RE: **Lot 28 Block 13 Unit 18 SAD 228
6523 Picardia NW
Volcano Cliffs Subdivision
Grading and Drainage Plan
Engineers Stamp Date 5/10/2021 (D10D003I28)**

Based upon the information provided in your submittal received 5/7/2021, this plan is approved for Grading Permit.

DRAINAGE AND TRANSPORTATION INFORMATION SHEET (REV 6/2018)

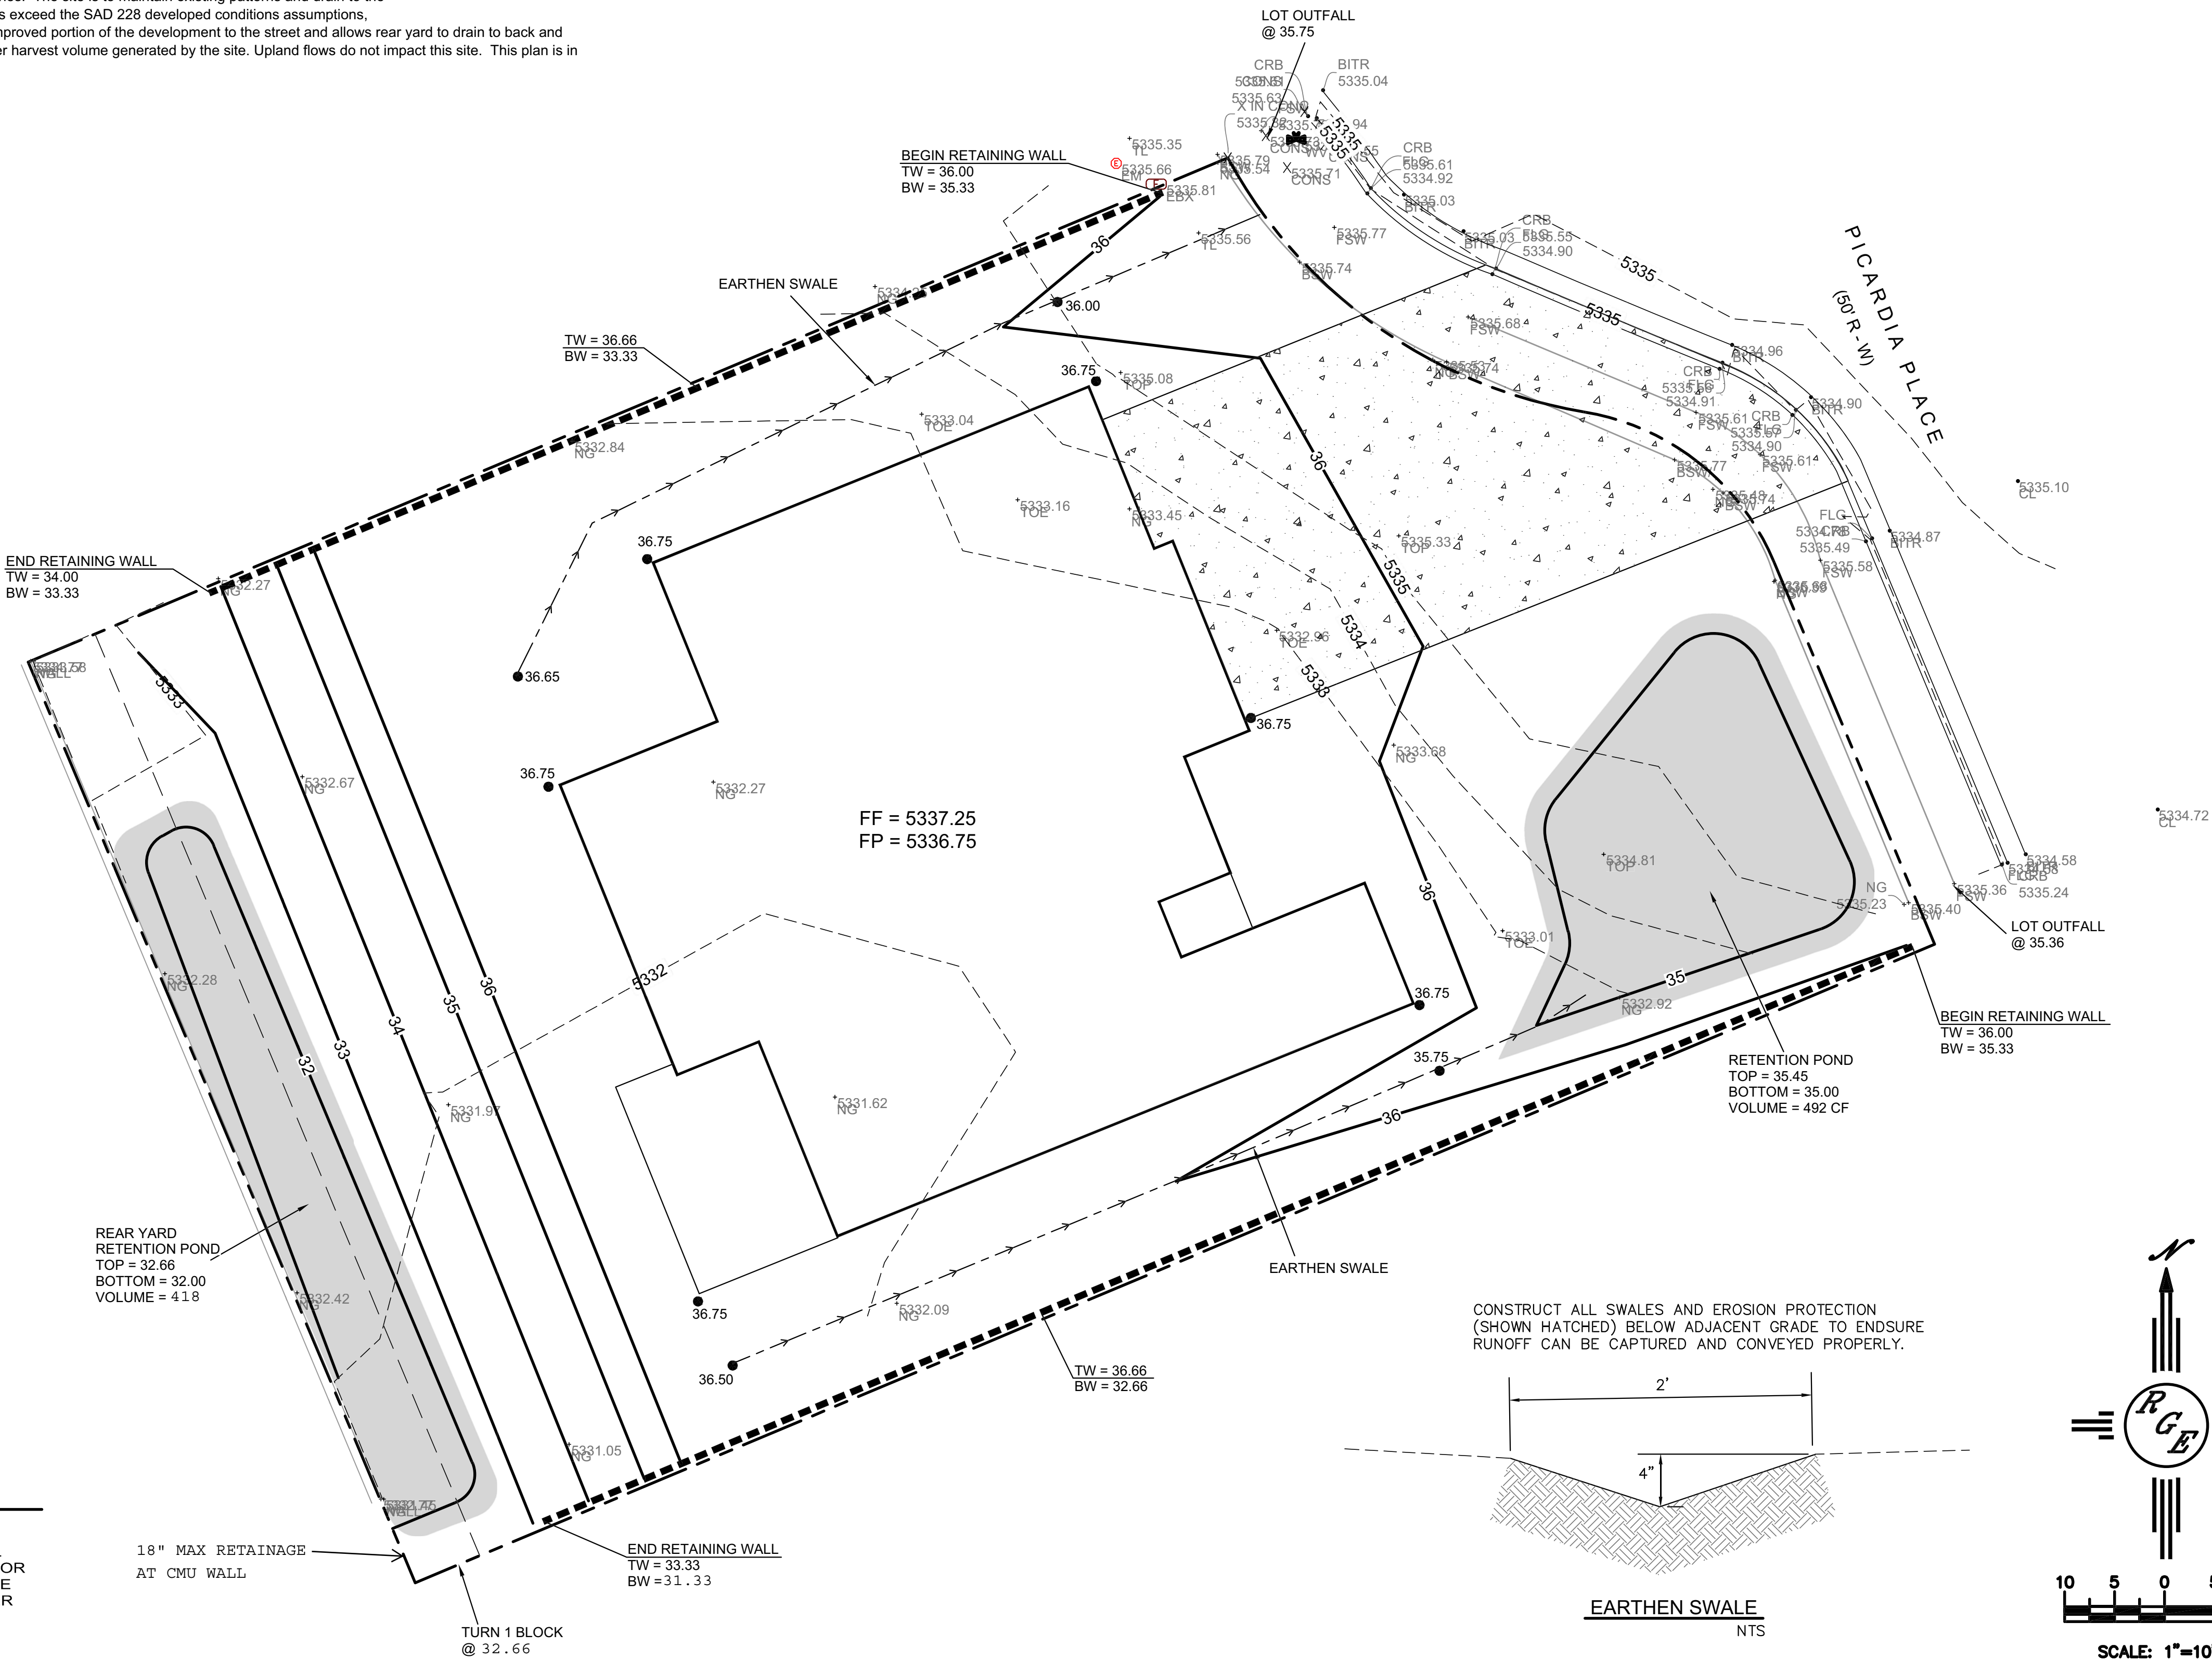
Prior to Building permit approval a Pad Certification will be required, provided by the Engineer or a registered Land Surveyor.

Advise the owner contractor not to use dirt as a ramp to climb the curb, use lumber or crusher fines for this purpose.

Reiterate to the Owner/Contractor that a separate permit for a garden/retaining wall must be obtained with the approved G&D plan and Pad Certification. Also, if a swimming pool is to be placed the grading and drainage plan will change and will need to be resubmitted.

Prior to Certificate of Occupancy release, Engineer Certification per the DPM checklist is required.
